**Western Star
Service Bulletin**

Description of Revisions: *This bulletin replaces the version dated July 2015. **Figure 3** has been revised to show the correct location of wire 36A.*

Fig. 1, Turn Signal Switch

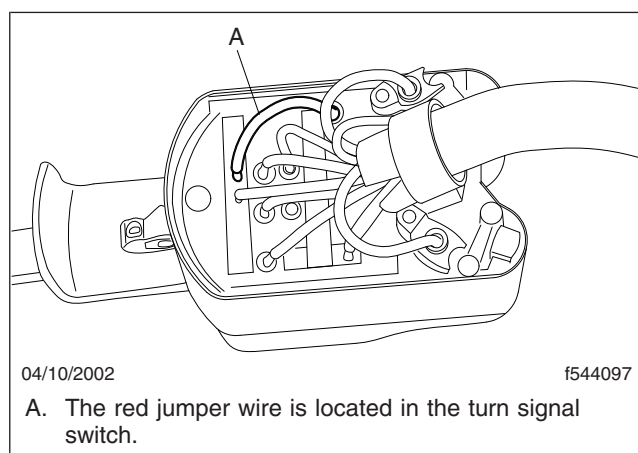
To enable 4-way override on all Western Star vehicles equipped without self-cancelling turn signal switches, remove the jumper wire located in the turn signal switch and tape it back. See **Fig. 1**.

Fig. 2, Auxiliary PDM Location

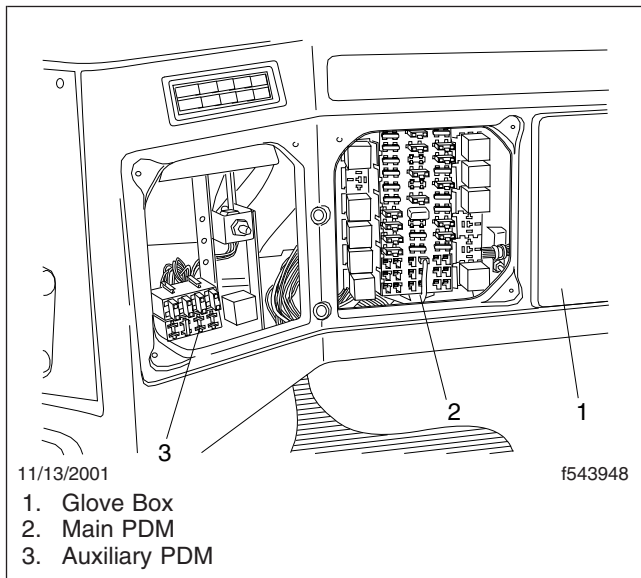
On 4700 models with self-cancelling turn signals, remove wire 36A (red with a white stripe) from cavity 85 on the auxiliary PDM, and tape it back. See **Fig. 2** and **Fig. 3**.
